Inverter Bonding Repair

Bulletin Type:	Recall	Publication Date:	July 2026
Bulletin #(s):	26V-427 USA 2026-323 Canada	Make(s):	Heartland
Job Code(s):	9905661	Model(s):	Cyclone FW, Cyclone TT
Flat Rate(s):	9905661 - .25 HR – Installation of ground wire to inverter	Model Year(s):	2026

Bulletin Type:	Recall	Publication Date:	July 2026
Bulletin #(s):	26V-426 USA 2026-322 Canada	Make(s):	Jayco
Job Code(s):	9901660	Model(s):	Seismic FW
Flat Rate(s):	9901660 - .25 HR – Installation of ground wire to inverter	Model Year(s):	2026

INVERTER BONDING INSTALLATION INSTRUCTIONS

Fig. 3

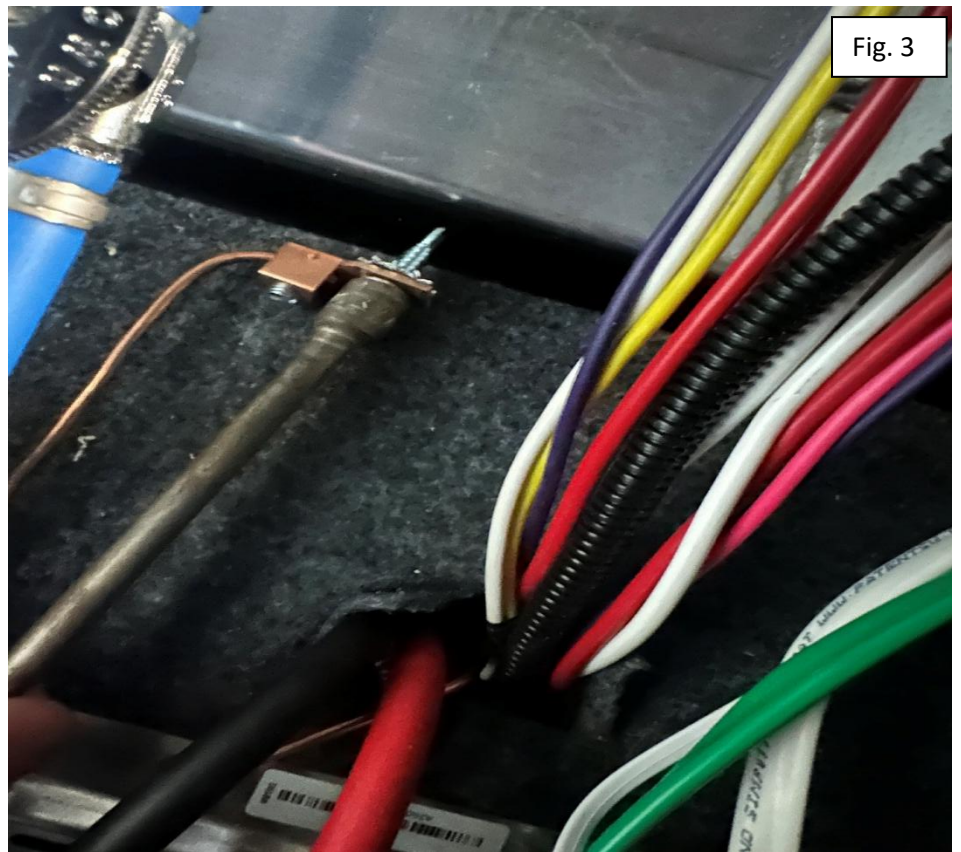
4. Cut ground wire to desired length and insert into ground port on inverter. Tighten the allen bolt with 5/64 sae allen wrench. (Figures 3 – 4)

Fig. 4

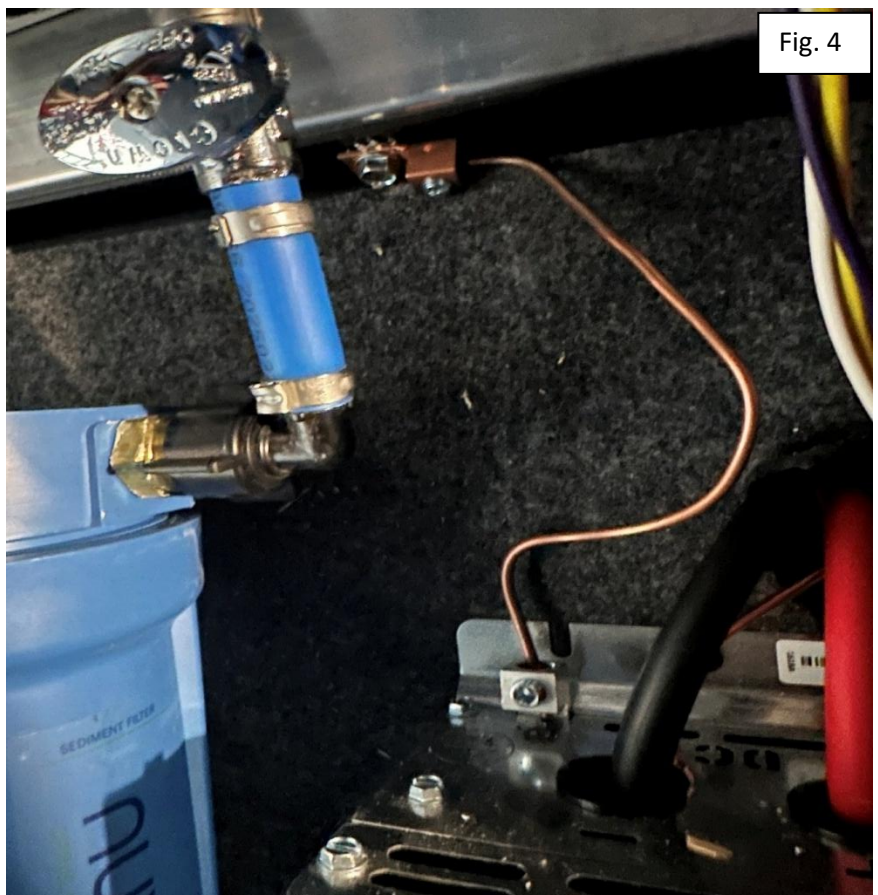
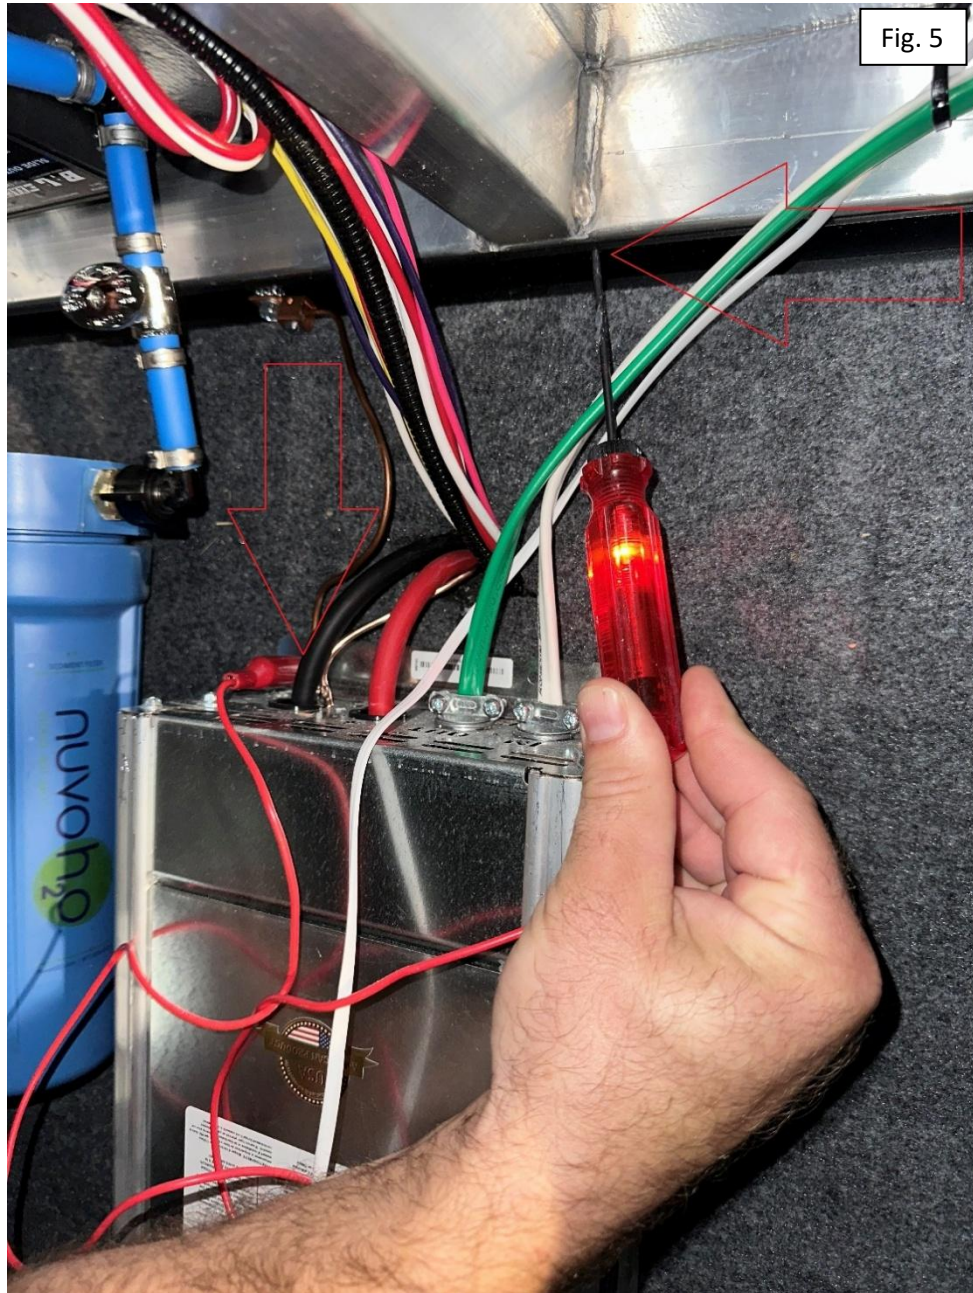
5. Do a continuity test from the ground pot on the inverter to the framing where you attached the wire and lug.
 - a. Move on to next step if test functions correctly.
 - b. Relocate lag screw to make sure lag is in steel framing, not aluminum floor framing if test does not function correctly. (Figure 5)

Fig. 6

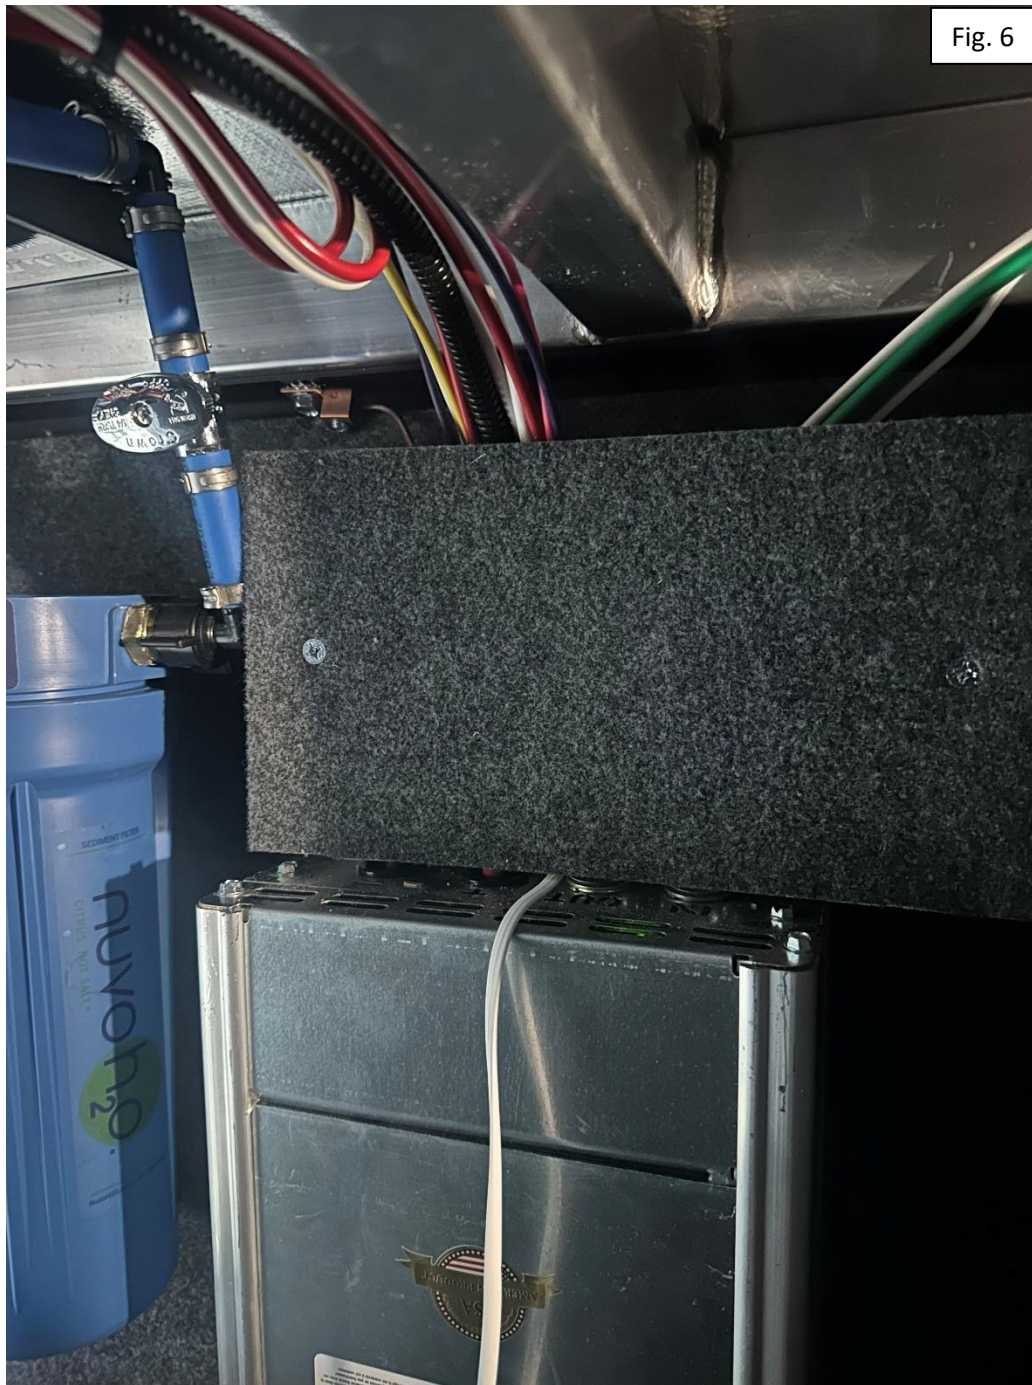
6. Reinstall felt cover as shown in figure 6.
